Architectural Review and  
Historic Preservation Board  
Agenda Report

File: AR 19-09

RE: Architectural Review 19-09 (The Humboldt)- 23-unit multi-family housing  
development, 1991 Humboldt Road, APN 002-110-034

PHOTOMETRIC PLAN

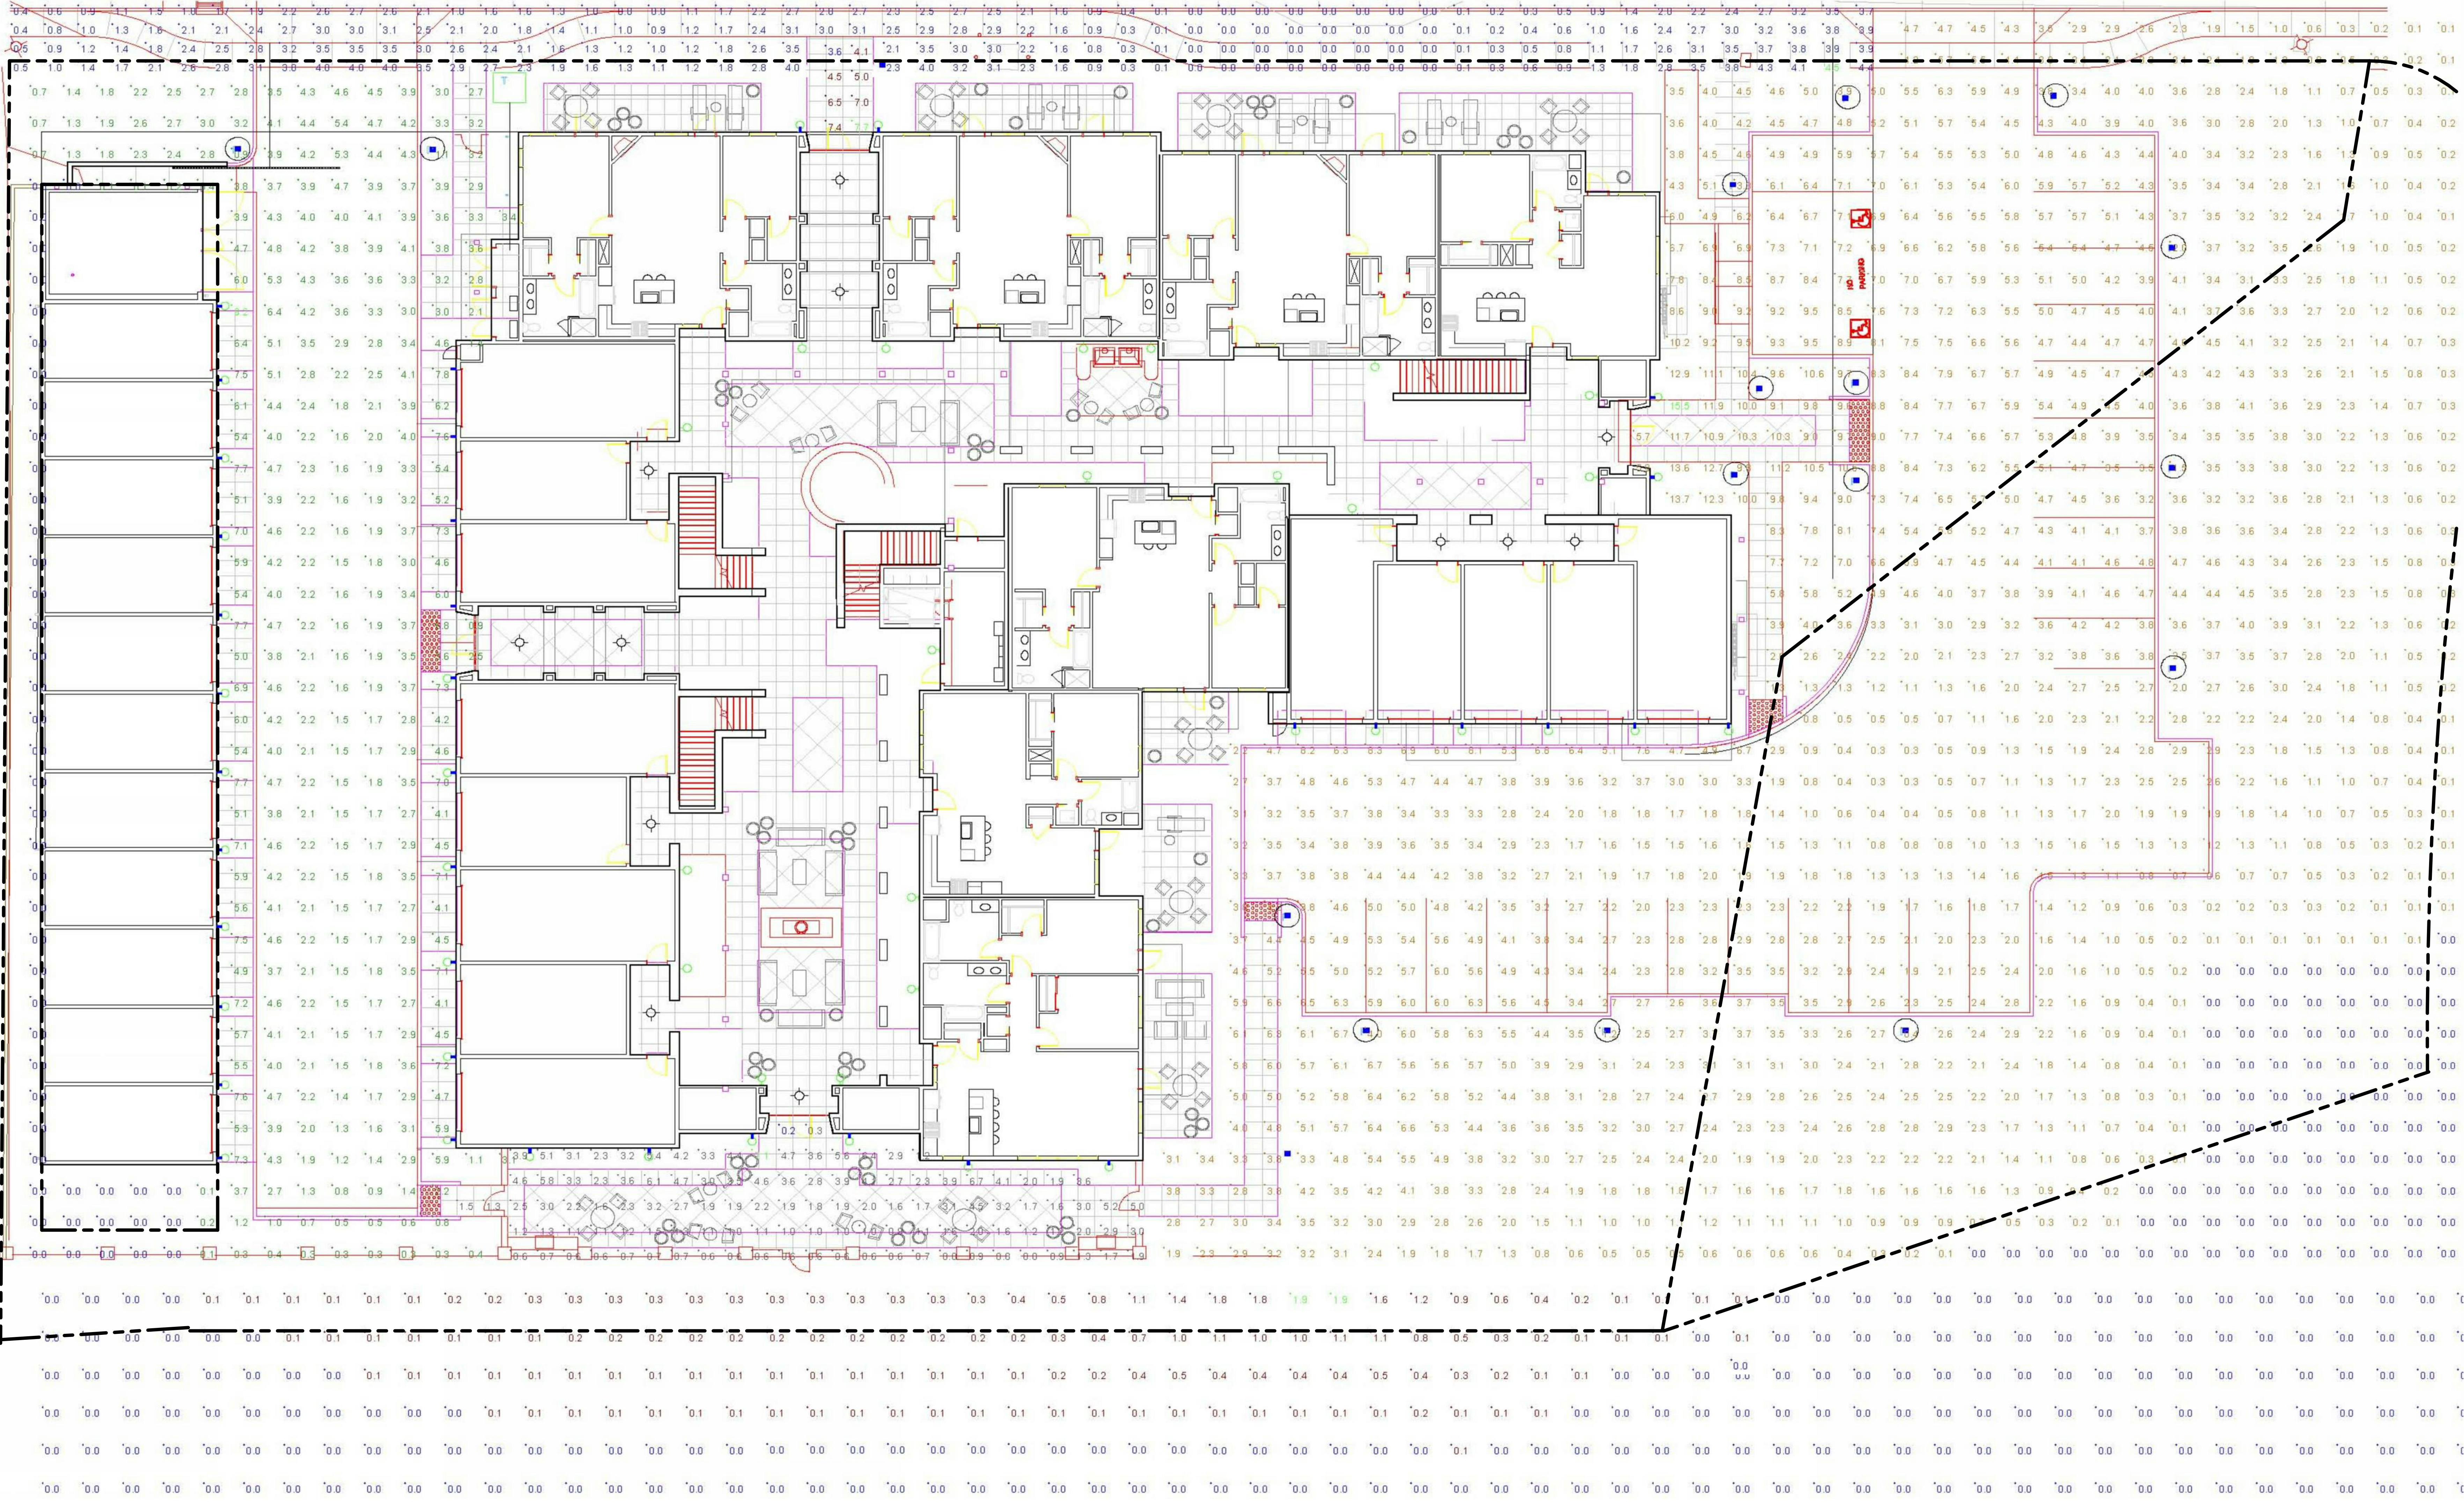
Decorative light fixture details throughout the project site would maintain the Monterey Style. Ornamental wall-mounted sconces are proposed to illuminate residential entries and walking areas as well as garage entries and the central courtyard. Hanging chandelier fixtures would illuminate breezeway corridors and low intensity pole fixtures are proposed throughout the uncovered parking area (see **Attachment F**, Photometrics Plan).
